Technical Service Information

THM 4T80-E NO ENGINE BRAKING AND OR DELAYED ENGAGEMENT IN THE D3 POSITION

Figure 1

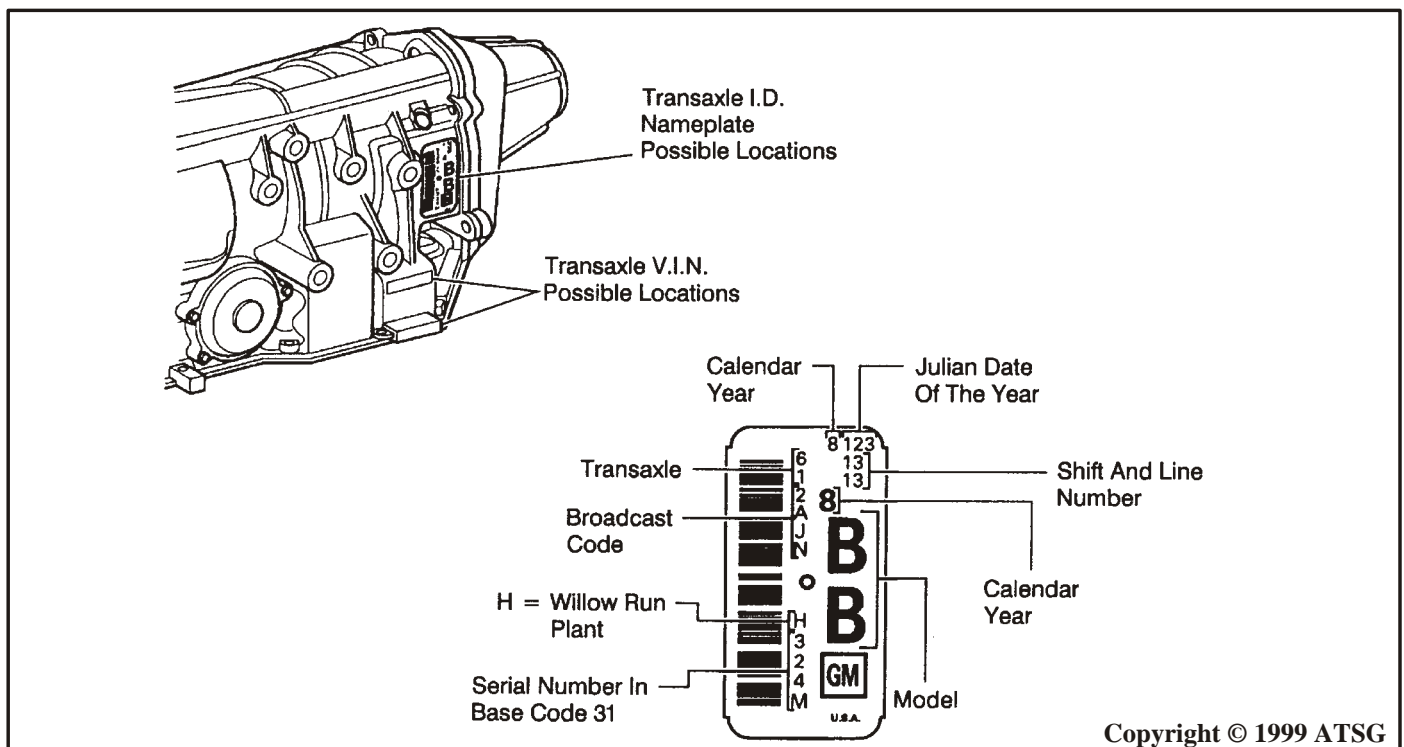
COMPLAINT: Units built prior to October 24, 1997, Julian date 297 (See Figure 1) may experience a loss of engine braking in the D3 position and/or a several second delayed engagement when selector lever is moved into the D3 position.

Figure 2

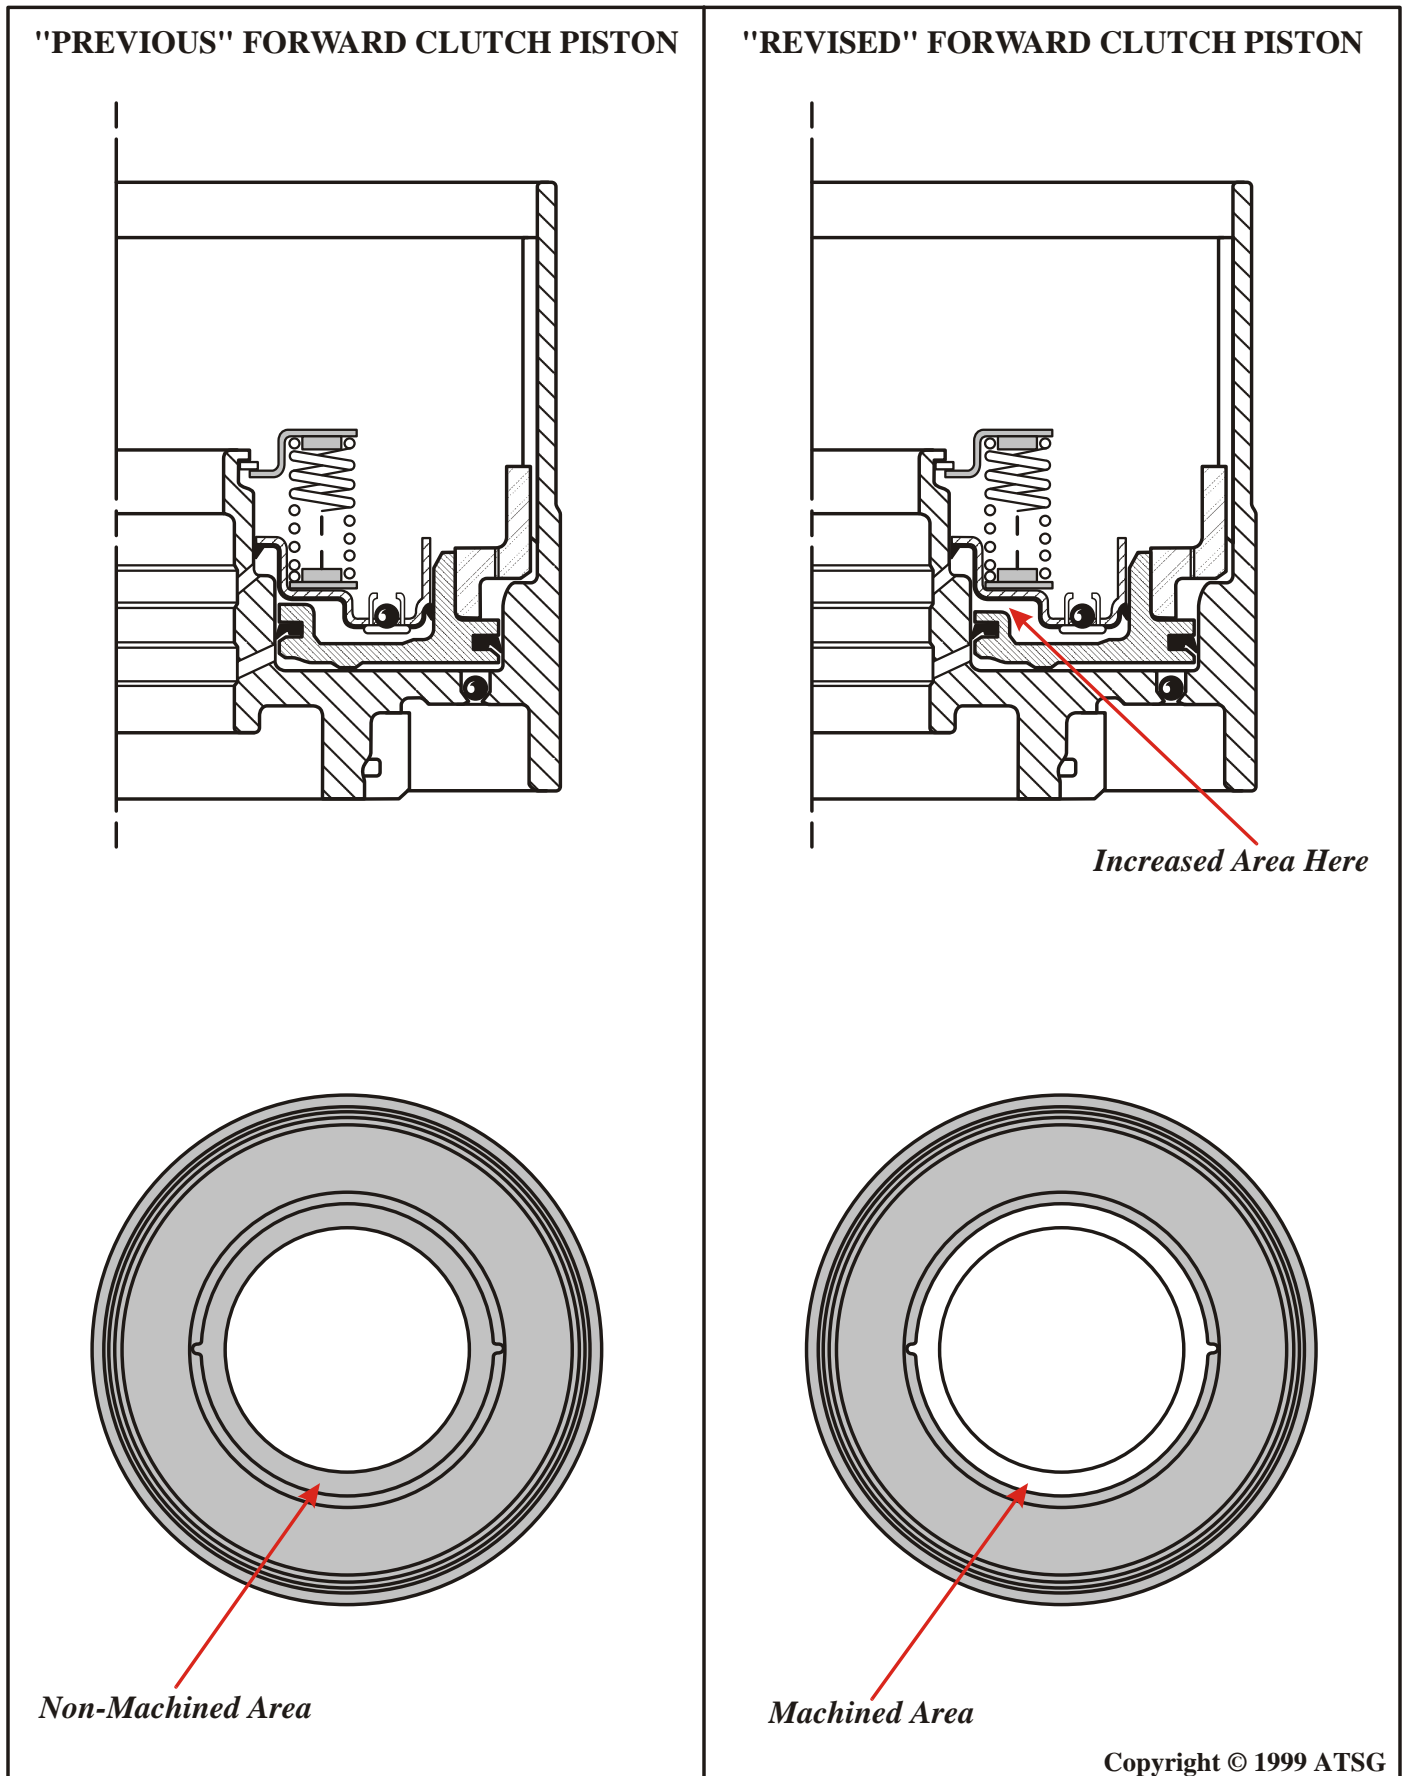
CAUSE: The complaint may be caused by the coast clutch piston side of the forward clutch piston restricting the coast clutch apply fluid (See Figure 2).

CORRECTION: There is now a revised forward clutch piston available where an additional machining process occurred, reducing the restriction of coast clutch apply fluid between the forward clutch piston and coast clutch piston. The new forward clutch piston can be easily identified by a shiny surface at the center hub of the forward clutch piston as shown in Figure 2.

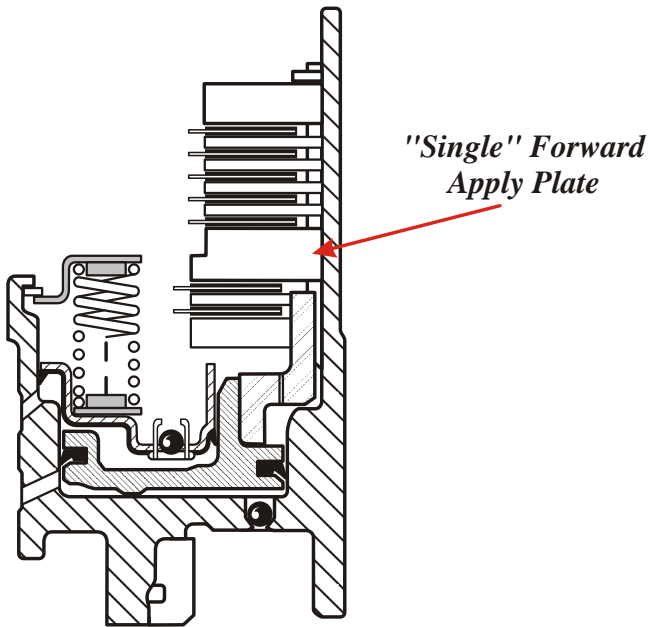
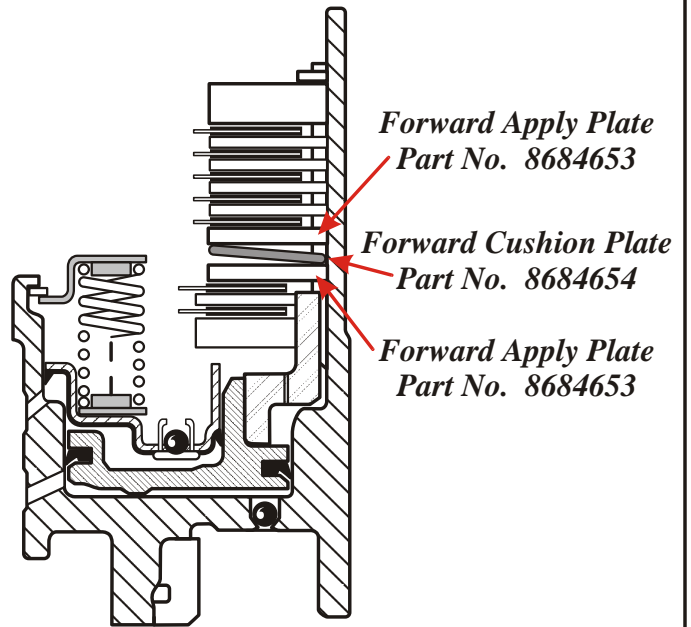
Special Note: There was also an another update that occurred on the forward clutch in model year 1994. The "single" forward clutch apply plate was replaced with a cone shaped cushion plate, sandwiched between "two" thinner apply plates, as illustrated in Figure 3, and should be updated during overhaul, if servicing a 1993 model.

**ALL 1993 MODELS SHOULD BE
UPDATED AS SHOWN ABOVE**
